Sheet: /STEPPER DRIVER X/hbridge_A3/
File: stepper_hbridge.kicad_sch

Sheet: /STEPPER DRIVER X/hbridge_A2/
File: stepper_hbridge.kicad_sch

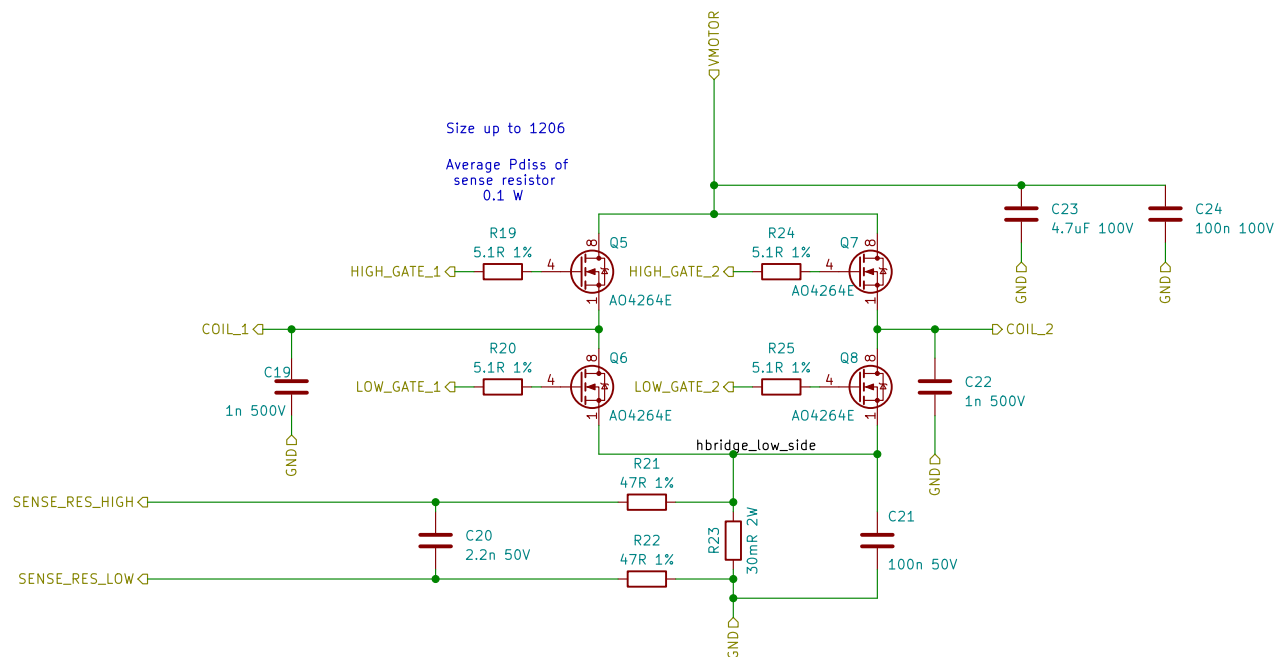
Size 10 ohm resistor (as a function of power supply charge). Also check for gate drive snubbing
